PLANS FOR: Lot 21, Riverfall

Reviewed for Fire Code Compliance
 Harnett County North Carolina Leslie Jackson
 02/23/2024 9:00:50 AM

MATTAMY HOMES - SEQUOIA LH

TITLE SHEET
T1.0

PPO - GROUND FLOOR PLAN - FARMHOUSE THIRD CAR GARAGE

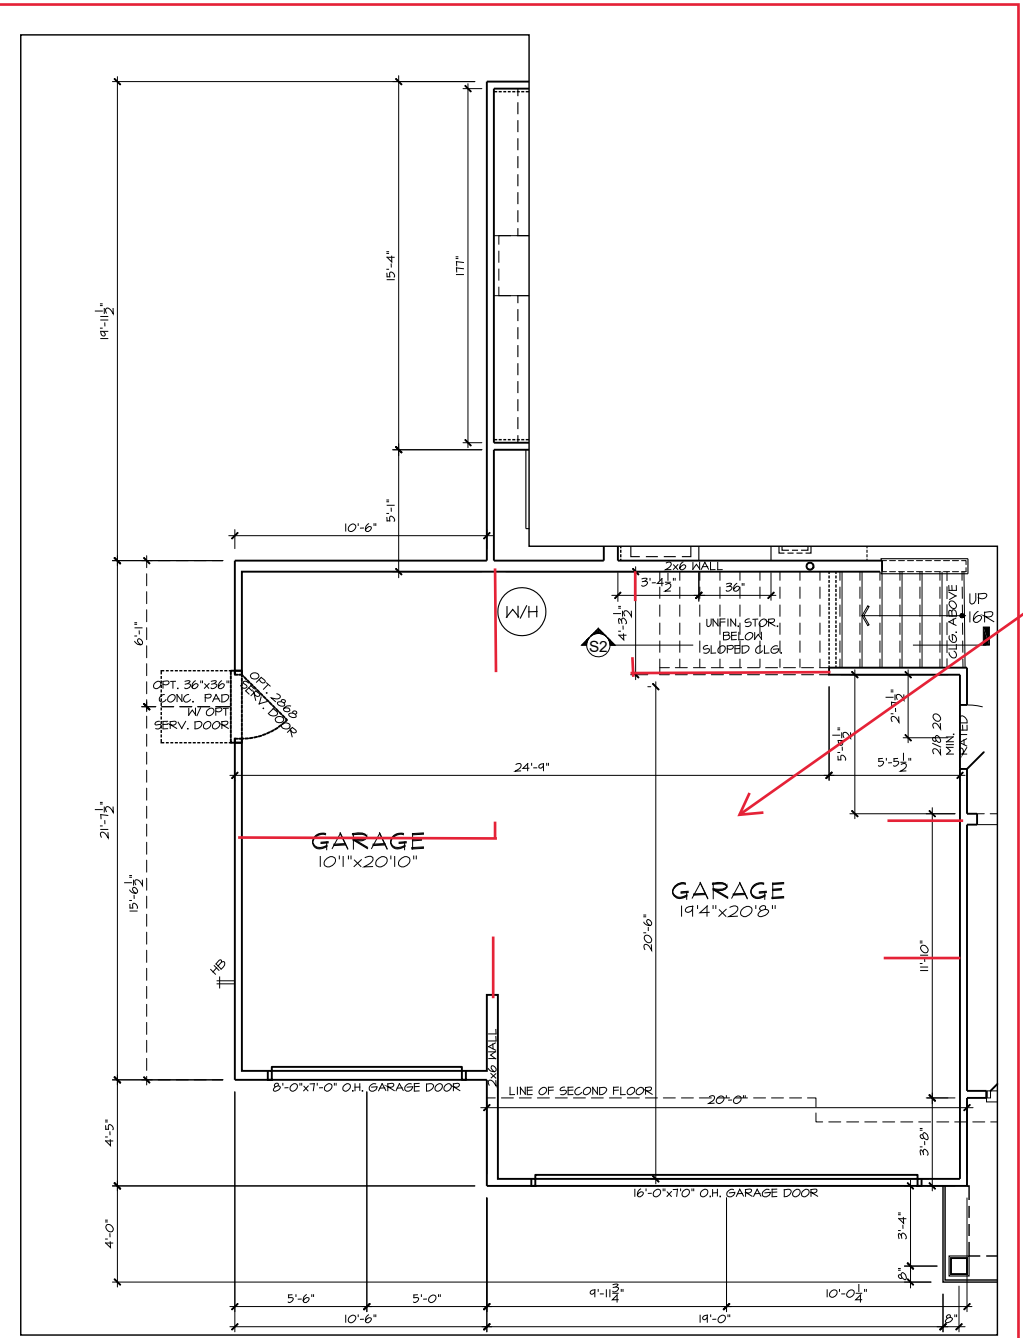
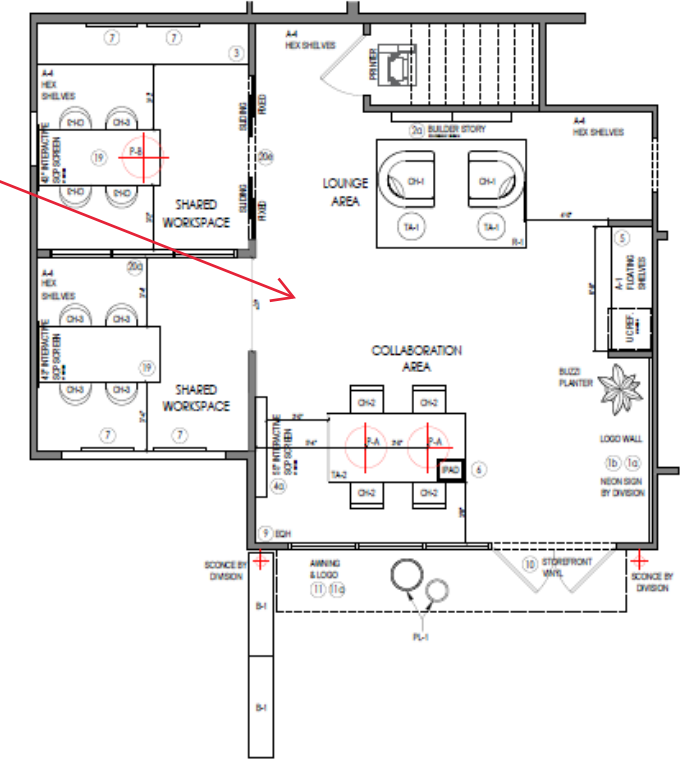
Sales Center in 3 Car Garage
Marked walls with red lines but look at Model Office Example

FIRST FLOOR CEILING FRAMING PLAN - FARMHOUSE

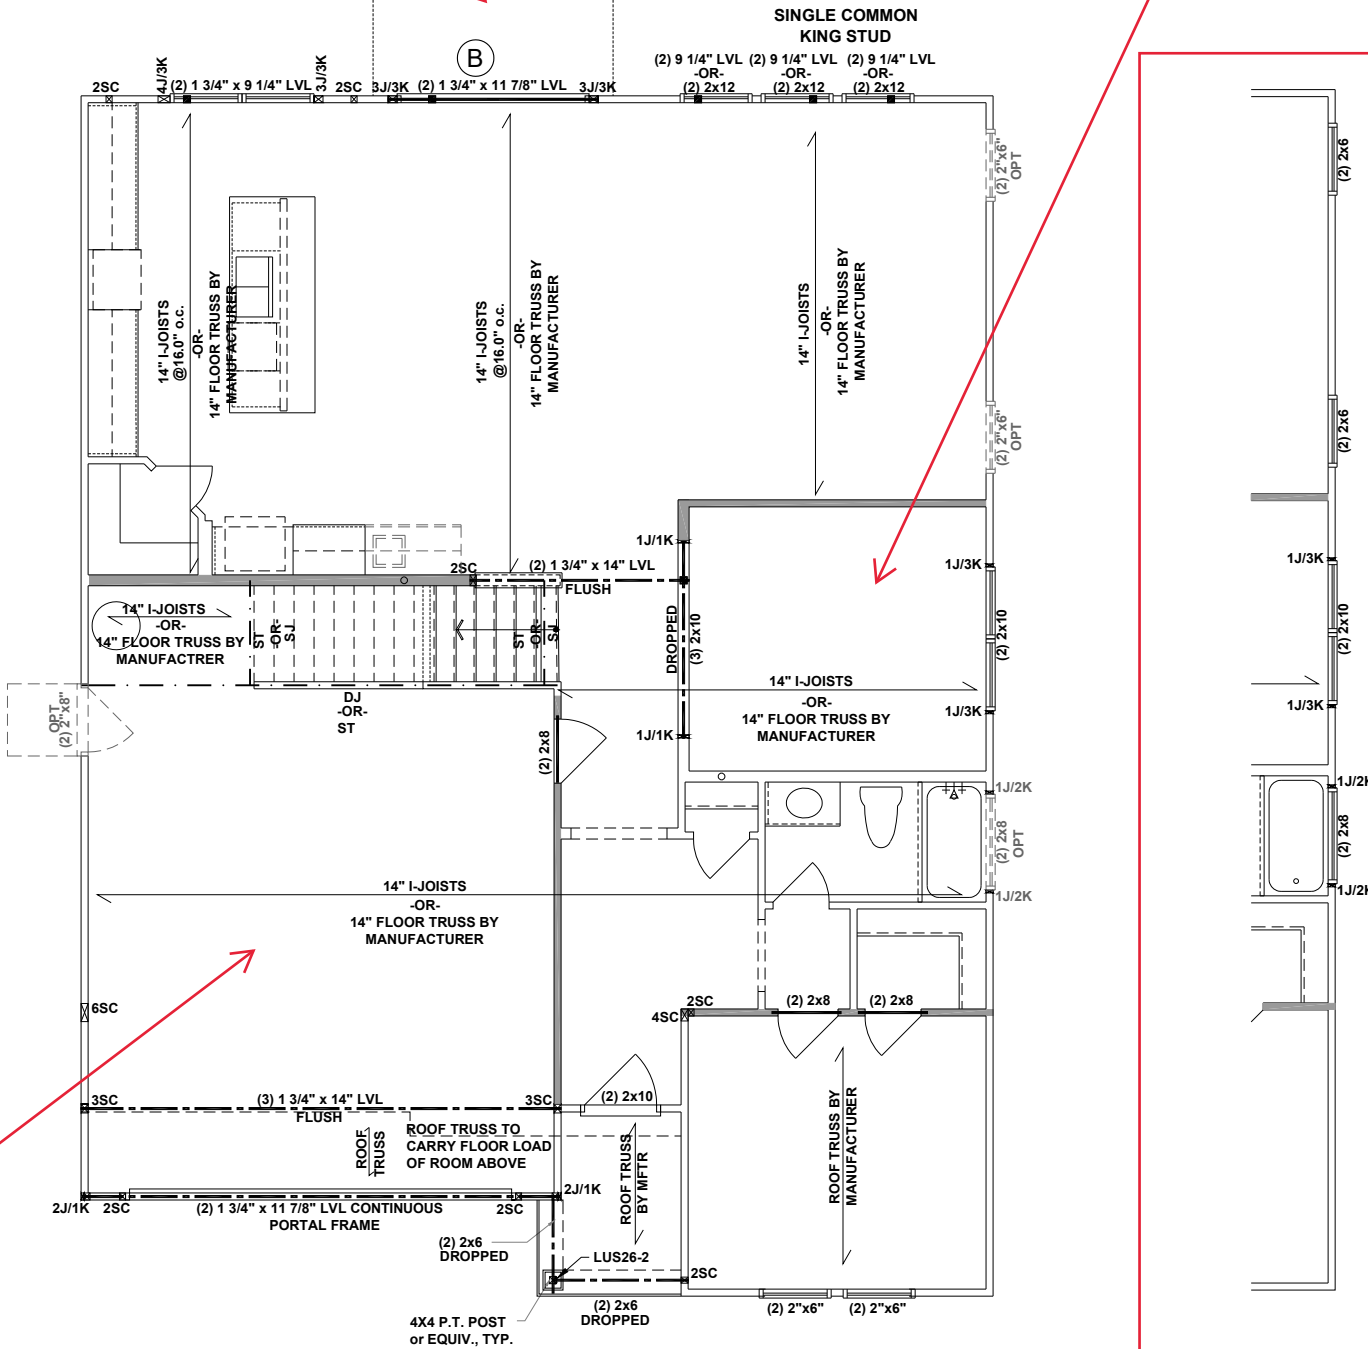
Screen Porch PPO See Page S1.1

Dining Room PPO See Page S1.1

FIRST FLOOR TRUSS CEILING FRAMING PLANS

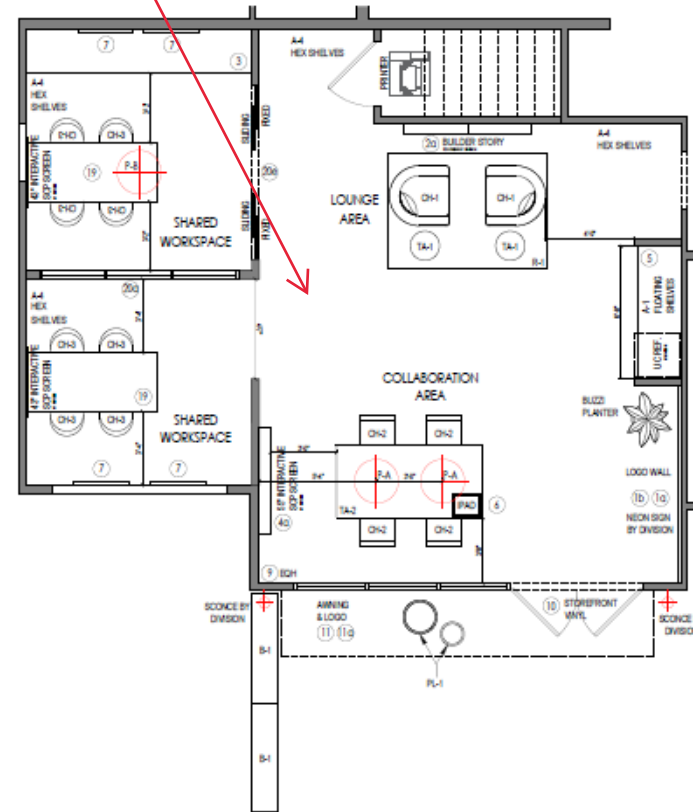
Sales Center Interior Design
